REQUEST FOR INFORMATION  
BID PACK B

PRE-BID RFI#: 001

PROJECT: SILVER LAKE ELEMENTARY SCHOOL

## Additions & Renovations to Silver Lake Elementary School

EAVE DETAIL  
A.SK-01

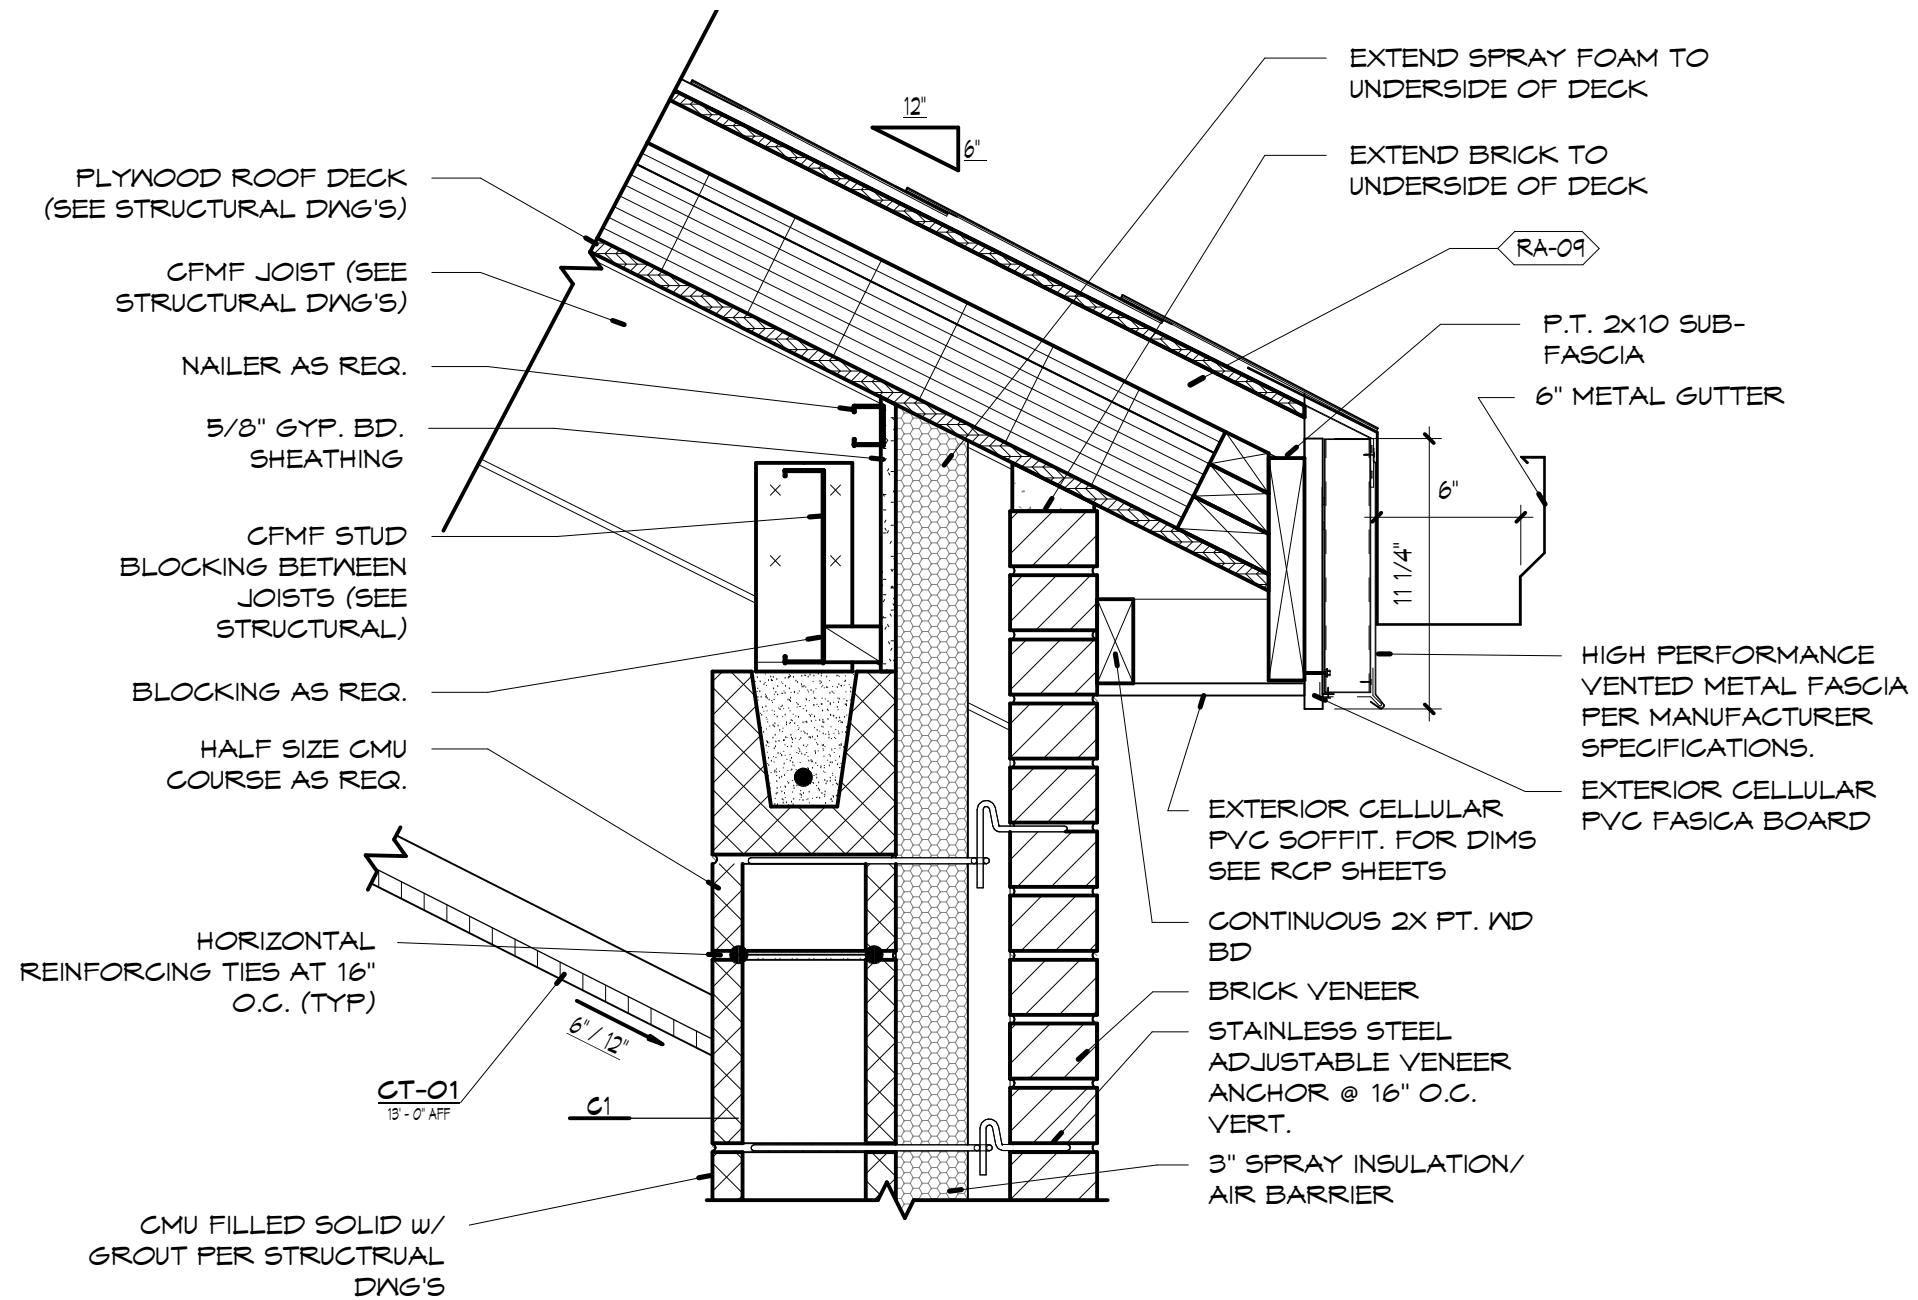
- 1.) Confirm that 5/8" plywood roof sheathing(deck type D1) as shown S11.A on 2' centers is the proper material for this application. Recommend making this 3/4" plywood.
- 2.) Section A42.1 cut through the eave of roof type RA-09 shows metal roof deck on detail 7 / A42.1 and references roof type RA-10. Resolve conflict.

- 1.) 5/8" plywood is acceptable as designed as long as it adheres to the requirements in general timber note T23, Drawing S02.
- 2.) Detail 7/A42.1 has been revised. Refer to sketch A.SK-01.

MODIFIES DETAIL 7/A42.1

**PROSCENIUM  
PILASTER DETAIL  
A.SK-02**

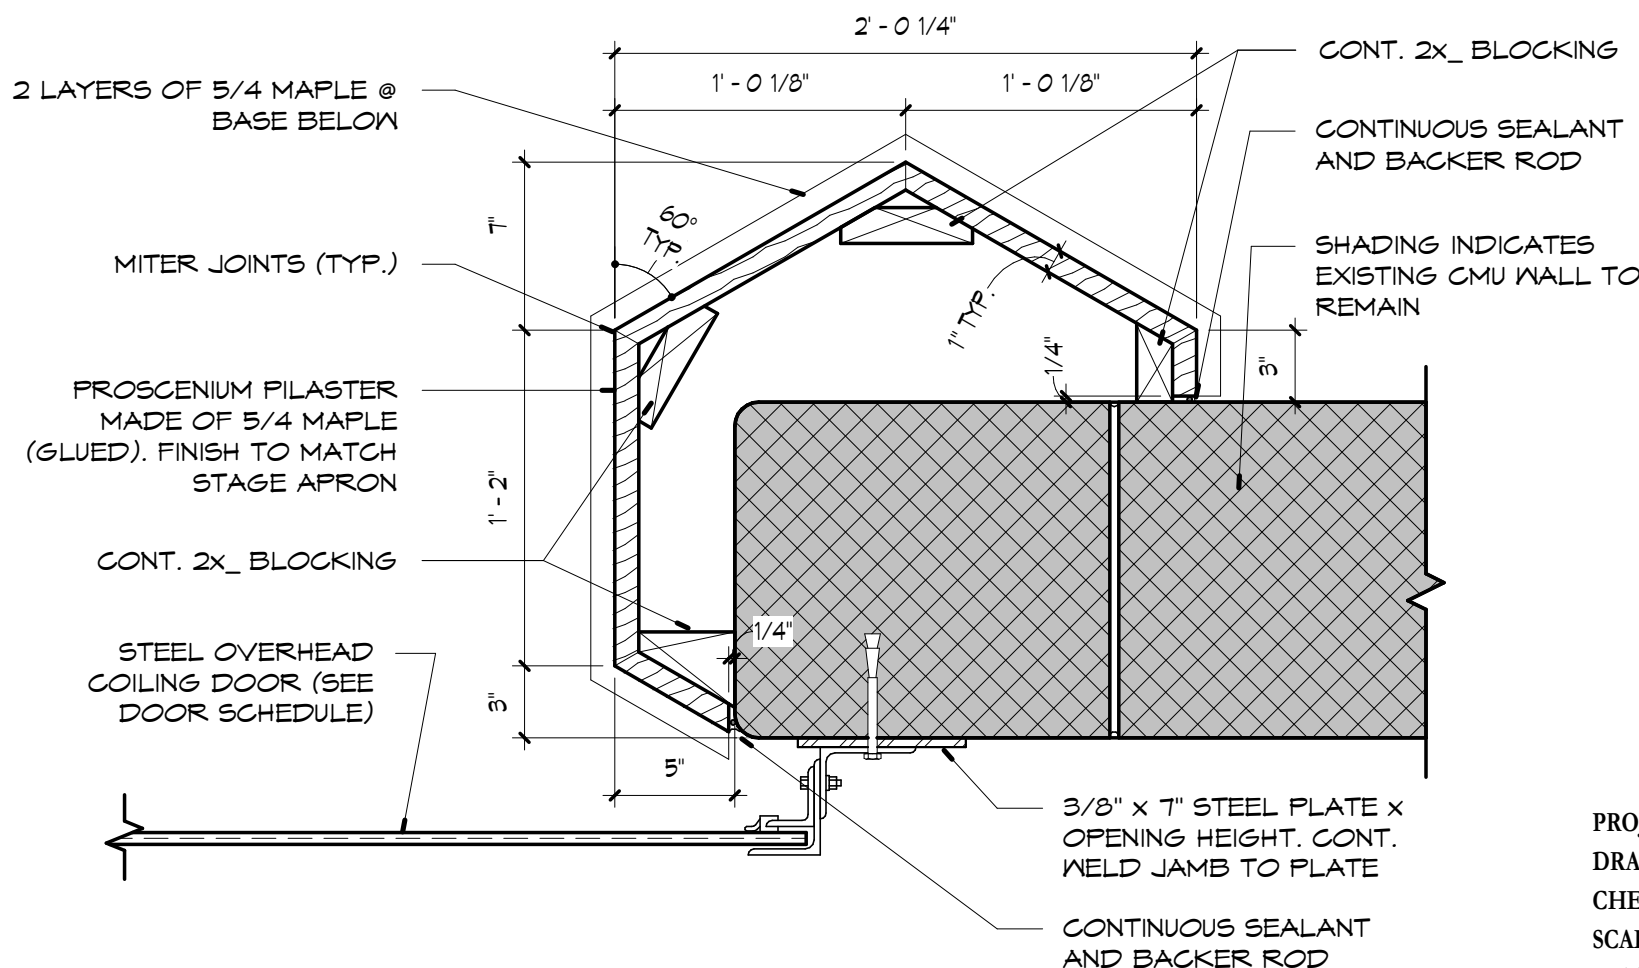
- 1.) Please provide specifications for the decorative FRP columns at stage proscenium, which is alternate #4f.

- 1.) The columns at the stage proscenium shall be constructed of wood and finished to match the new stage front. See attached sketches A-SK-02 - PROSCENIUM PILASTER DETAIL and A-SK-03 - PROSCENIUM PILASTER ELEVATION for construction of column cover.

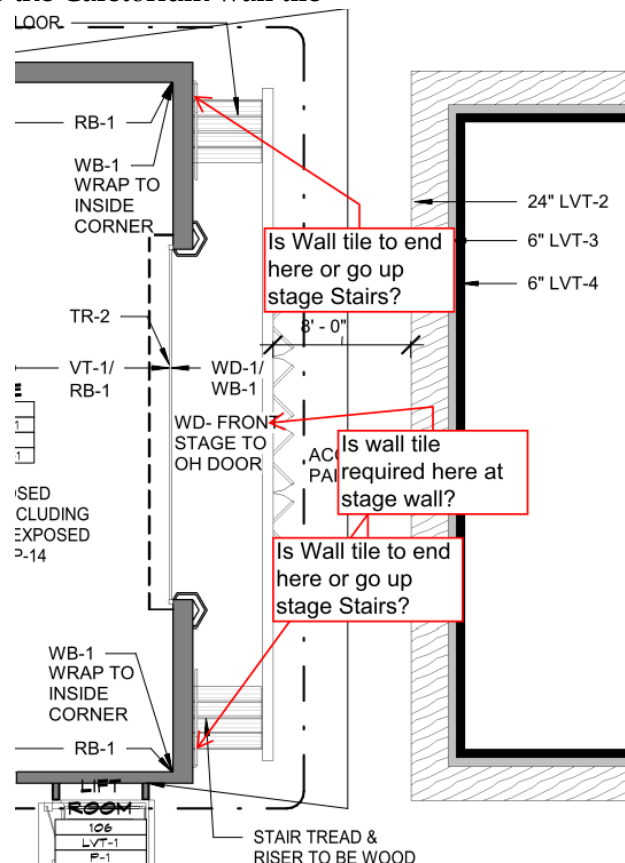
- 7.) Please reference the following picture and questions below along with sheet A90.A in reference to the Cafetorium wall tile

- 6) Refer to Addendum #2 for revised bid schedule.
- 7) No tile at stage front. Wall tile to end at outside corners of side stage walls. Provide Rondec edge at outside corners.

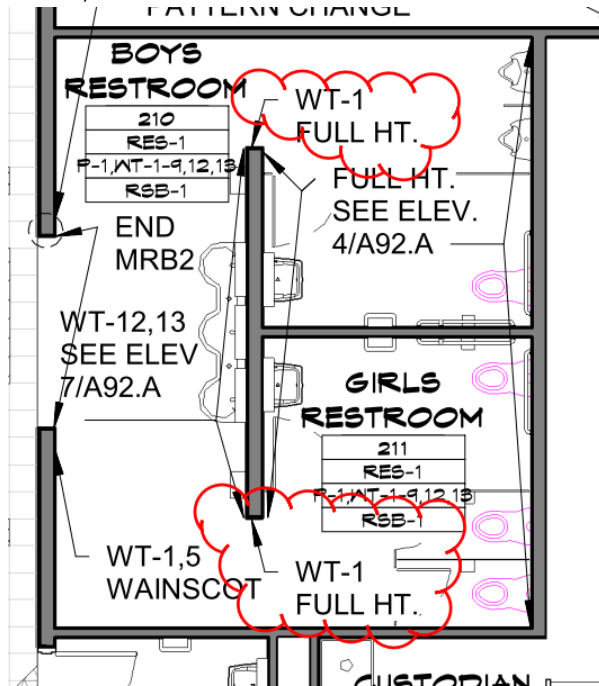
- 14.) For restrooms 127 and 126 can you please provide a clear drawing with arrows depicting exactly where tile is supposed to start and stop (ex. Wall to wall or does tile only go around sinks)? The current drawing is a little unclear.

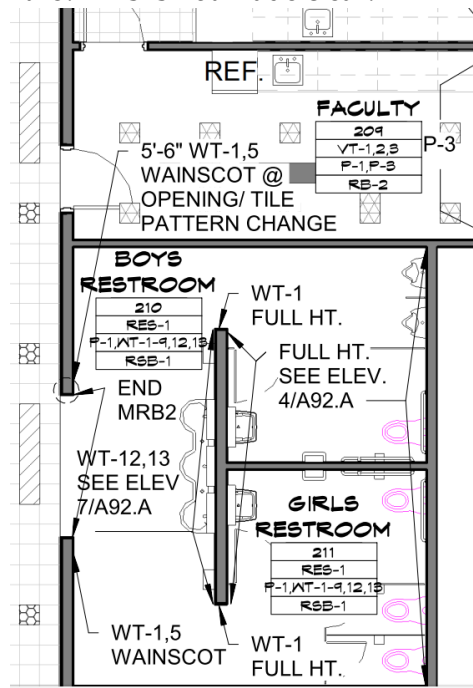
15.) Please reference the following drawing below. We note that WT-1 is meant to wrap full height on sides of walls. Can you confirm this is meant to be the same pattern referenced by Elevation 4/A92.A or WT-1 without an accents?
